UNITED STATES PATENT AND TRADEMARK OFFICE

Office Action Summary	Application No.	Applicant(s)	
	10/050,171	WATANABE	
	Examiner	Art Unit	
	Matthew E. Warren	2815

DETAILED ACTION

FIG. 77A

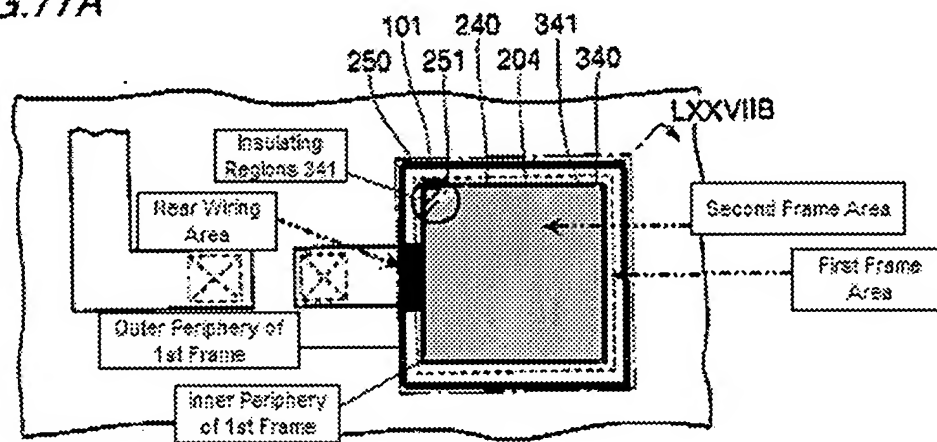
Since there is confusion as to what the near wiring area of Harada is, figure 77A has been provided below with the various portions labeled. As scene from the figure below, there is a first frame area and a second frame area within the first frame area. The outer periphery of the second frame area is actually the inner periphery of the first frame area. The insulating region (341) at each corner of the pad part is located within the second frame area. There is a near wiring area that extends into the first frame area. The insulating region (341) is not formed in the near wiring area. Harada was only deficient in showing that there are a plurality of insulating regions in the second frame

FIG. 77B

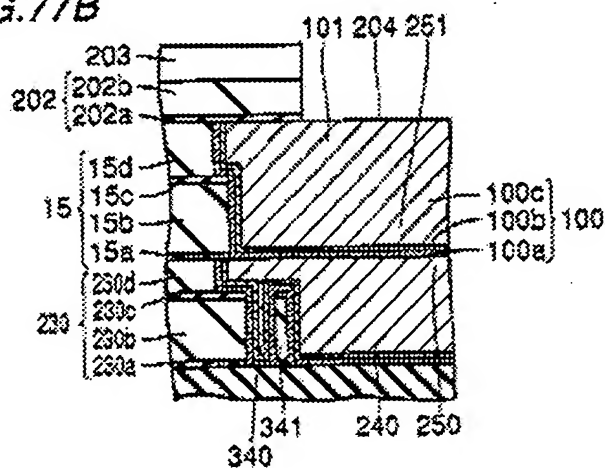
Furthermore, the applicant argues that the insulating regions, first pad, and wiring of Harada are not formed in the same layer as the first intra-layer insulating film because Harada has a multi-layer structure. However, an intra-layer insulating film may comprise several films. In Harada (fig. 77) films 230a, 230b, 230c, and 230d all make up

intra-layer insulating film 230. The applicant's specification (page 9) also states that the intra-layer insulating film comprises multiple layers.
